## Development Review Division

**DATE:** Feb. 26, 2021

**SUBJECT:** SP20-131 Site Plan – Planning Review 1

**LOT 6 PARKER AND PINE FILING 1**  
 PARKER, CO  
 EVERBROOK ACADEMY SITE PLAN  
 SITE PLAN

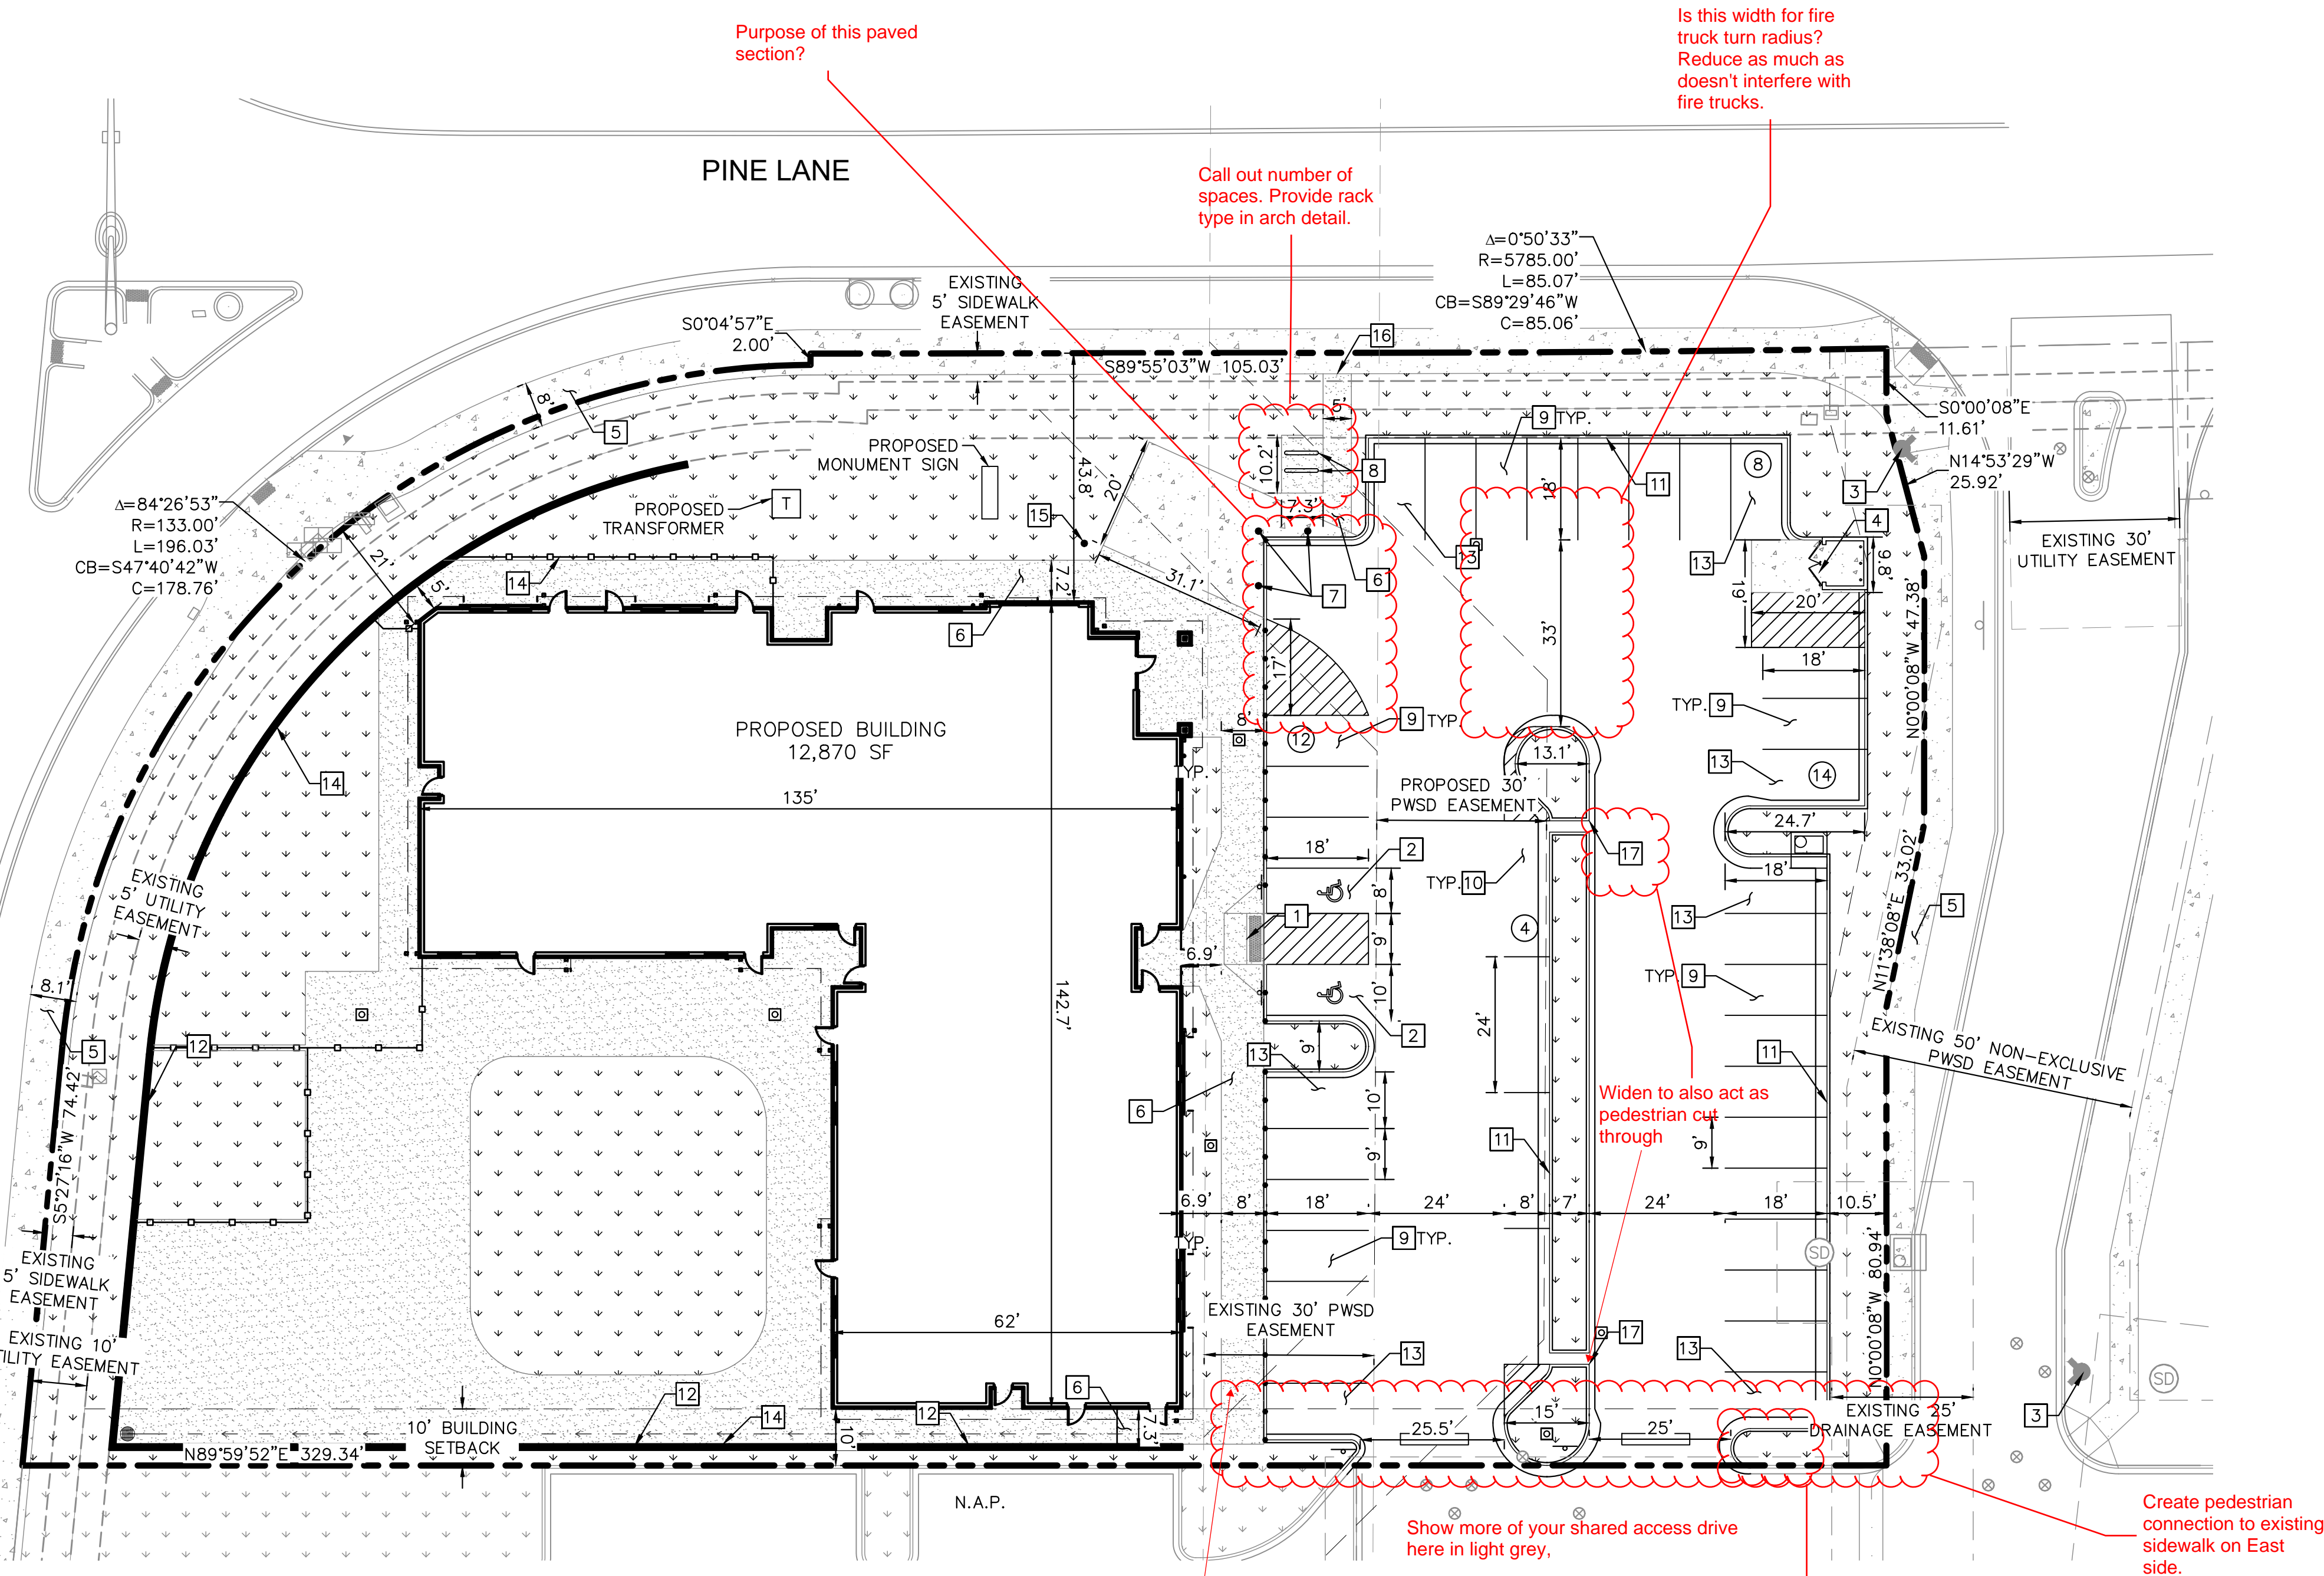
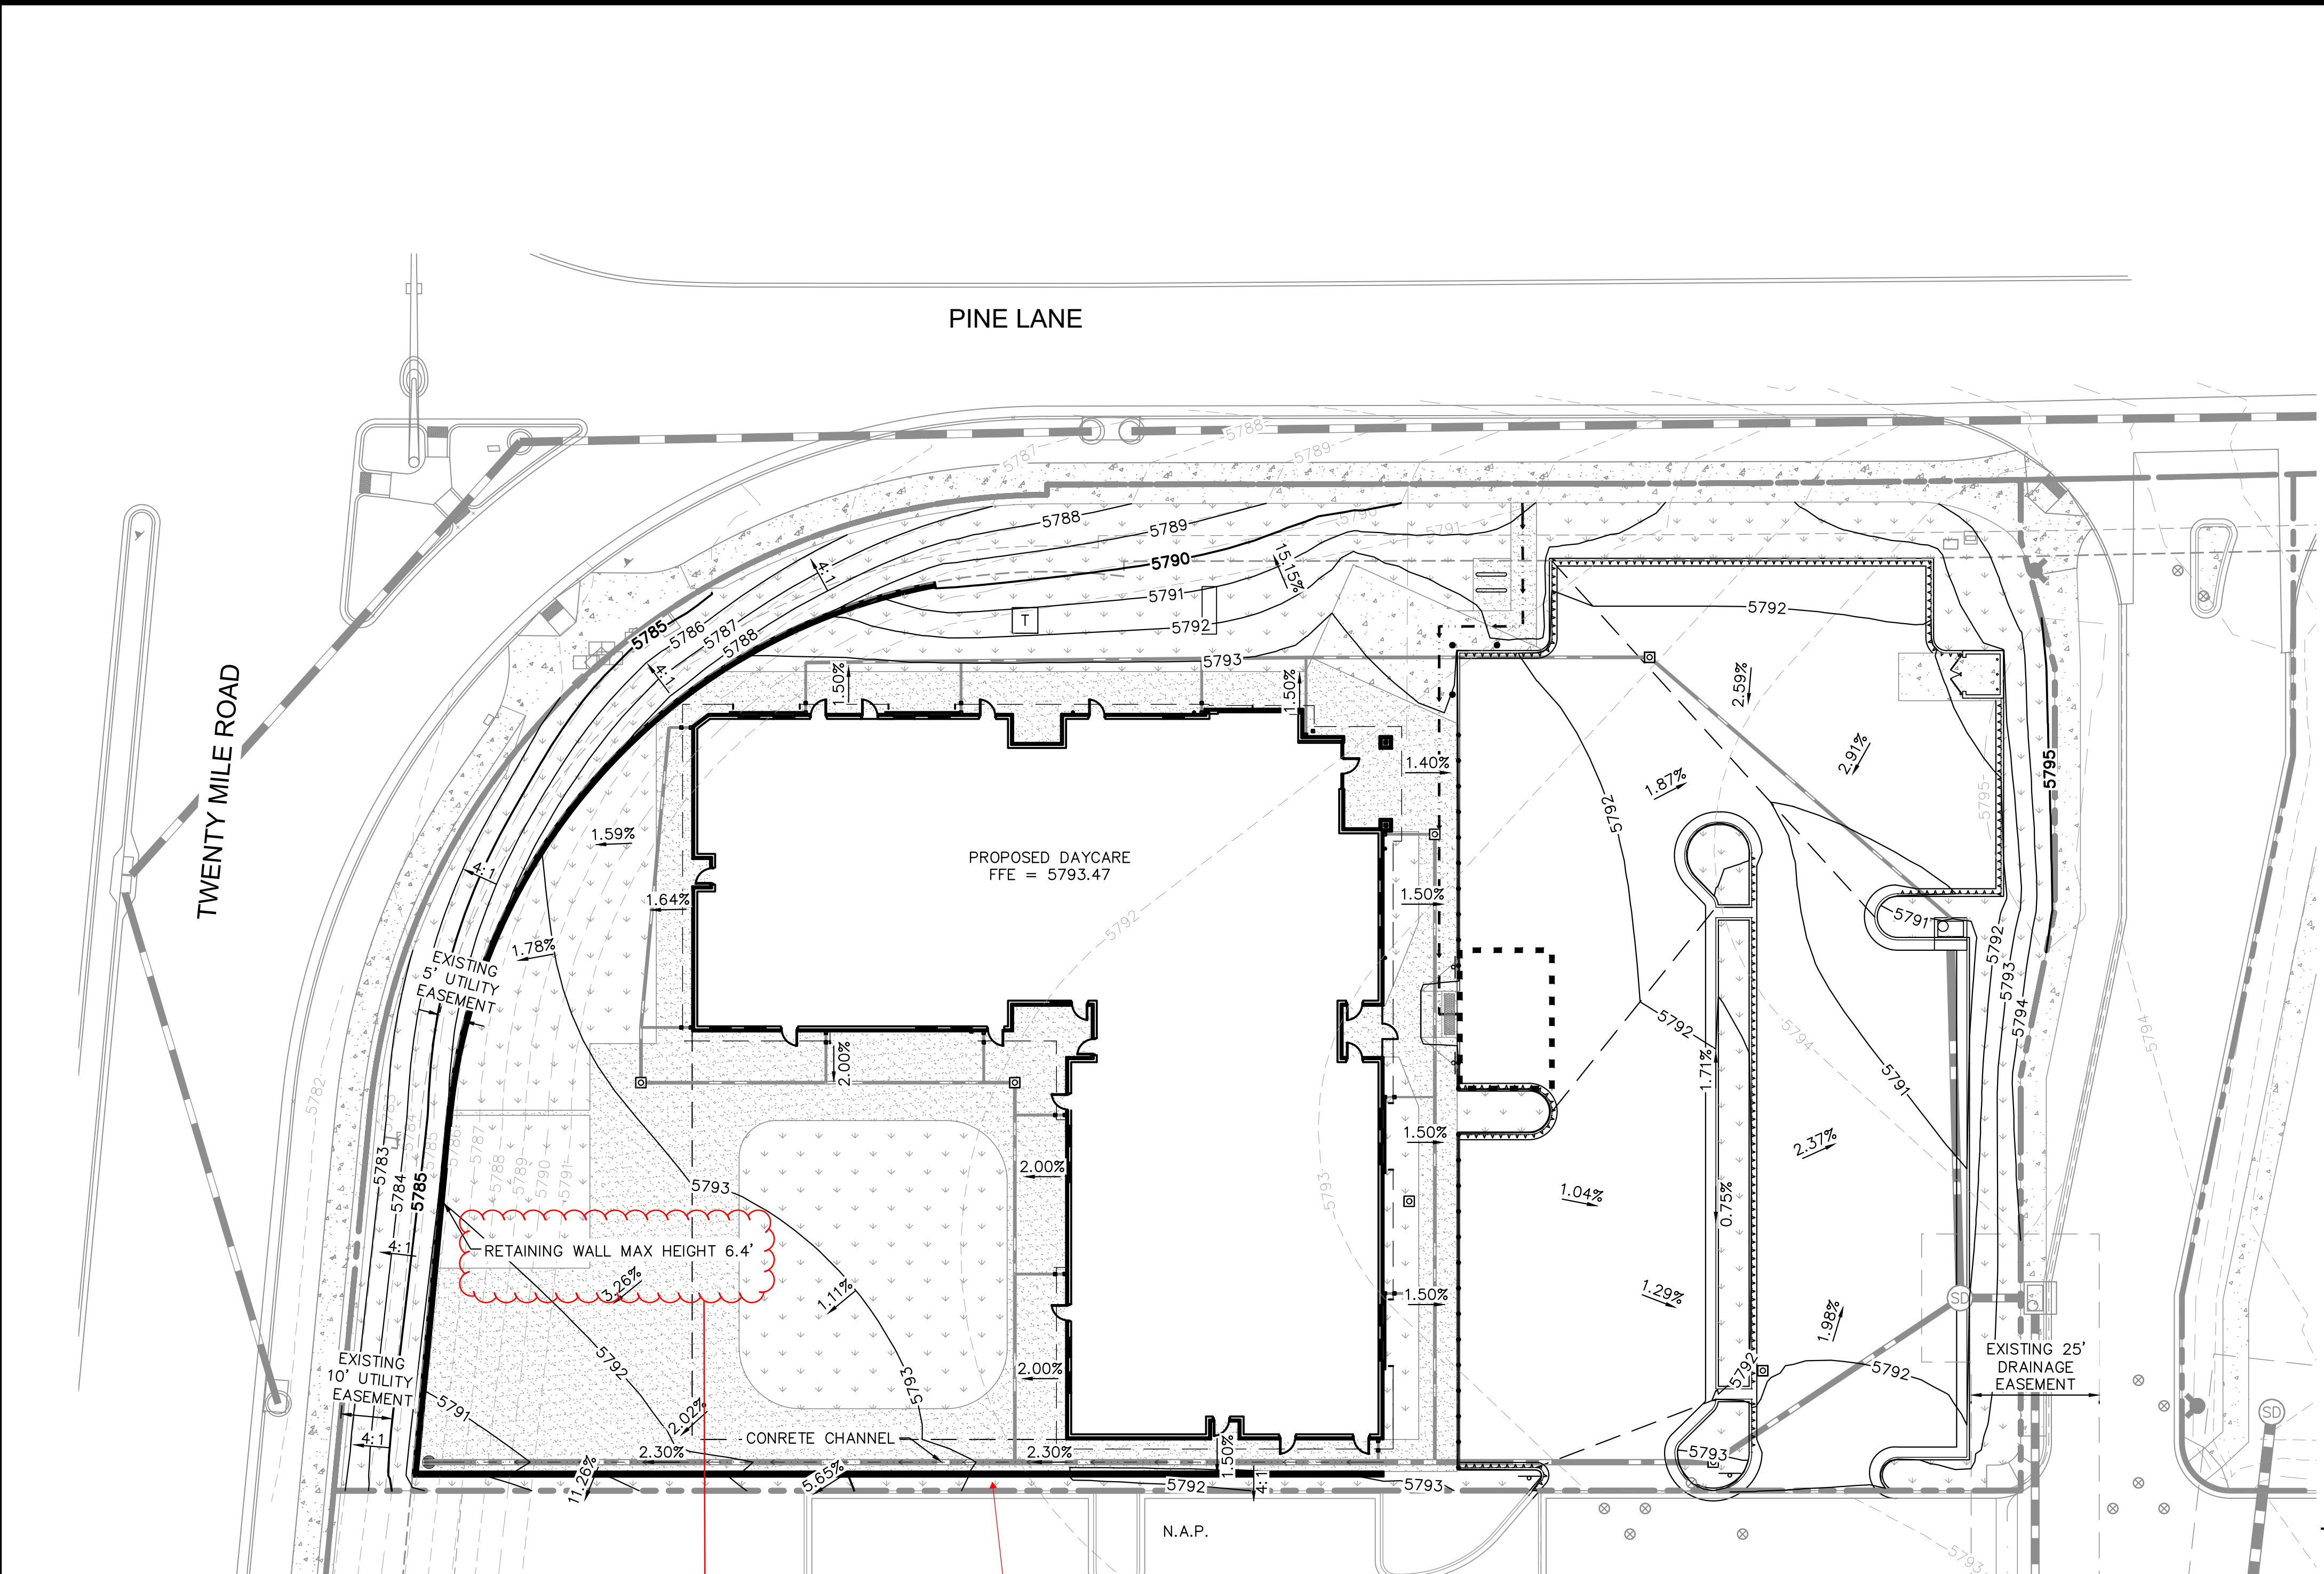
Notes 12 and 14 are pointing to the same black line. It's impossible to tell what's going on here. Are they stacked? Switch from one to the other along the length? Please clarify.

- 16 PROPOSED 5' WIDE PEDESTRIAN CONNECTION.
  - 17 2' WIDE CURB CUT Delete the word proposed in all references. Just add "existing" if it is already on site.

**LOT 6 PARKER AND PINE FILING 1**  
 PARKER, CO  
 EVERBROOK ACADEMY SITE PLAN  
 GRADING PLAN

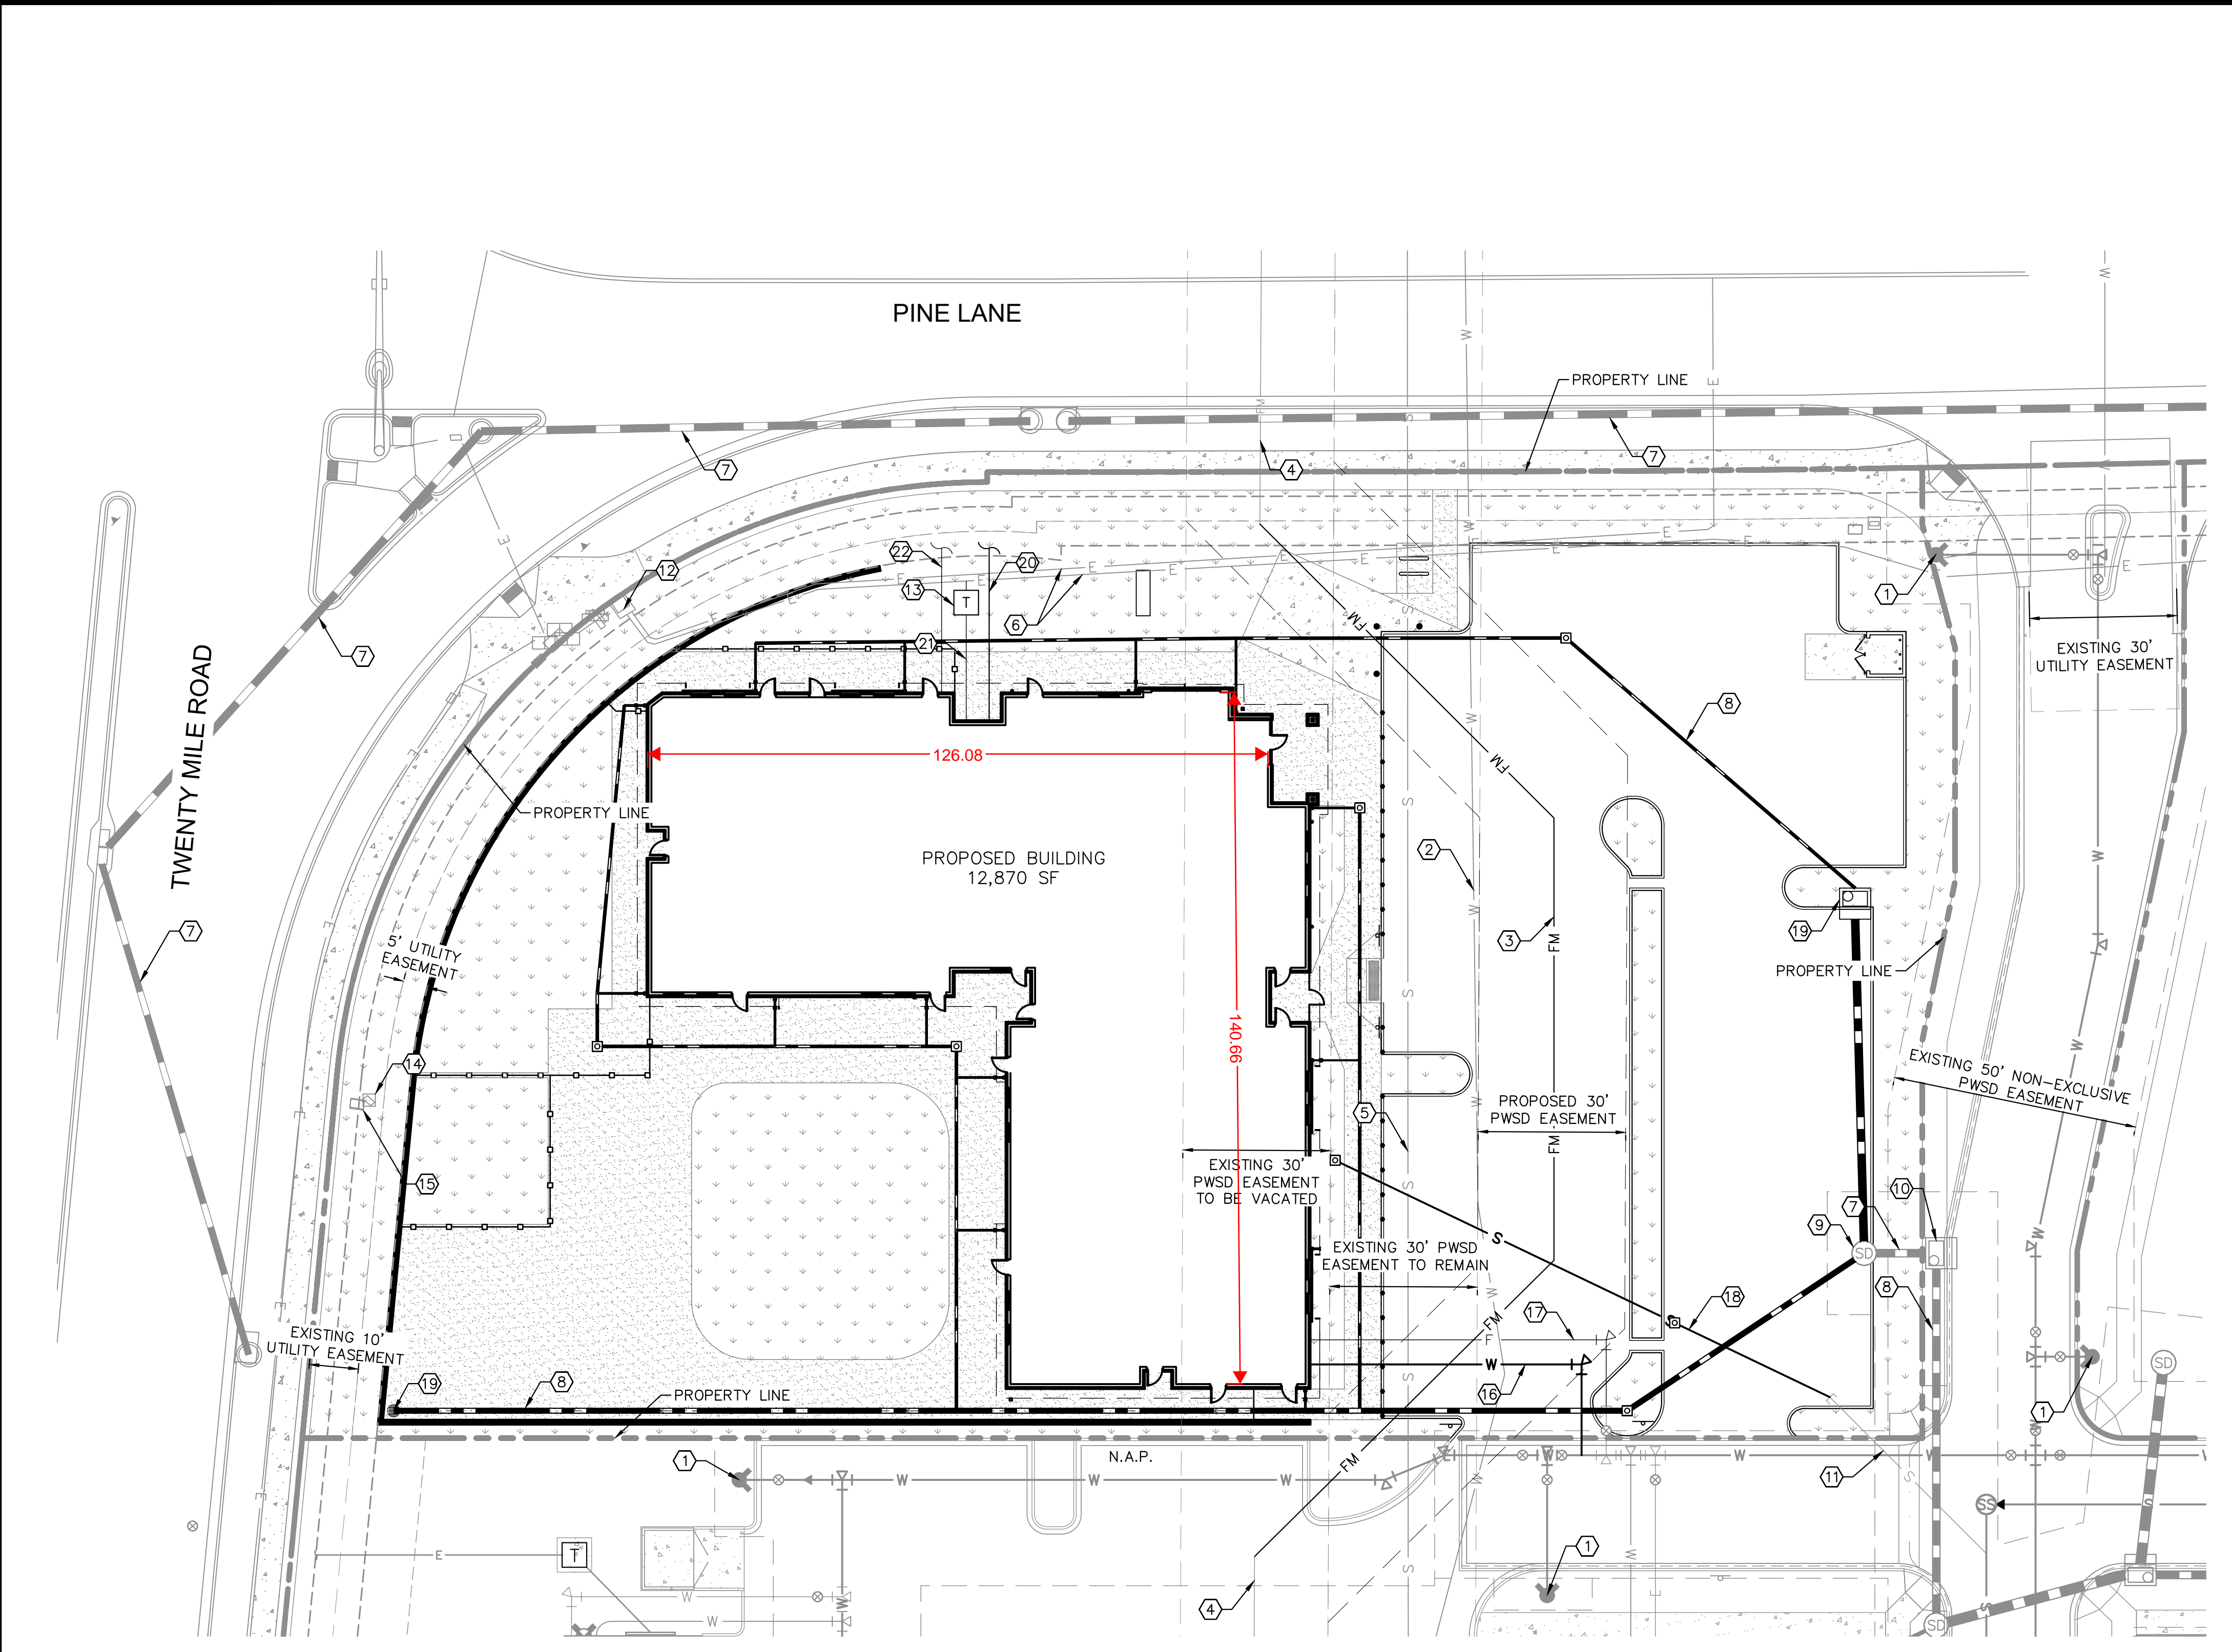
Above 4', a building permit is required for a retaining wall. Provide elevations and materials for wall.

You're putting a retaining wall along this edge? There doesn't appear to be any elevation change. Or has this transitioned to being a fence here? Please clarify. Label line type, add to legend. Create two separate line types for the wall and fence if they are not joined the entire length of both.
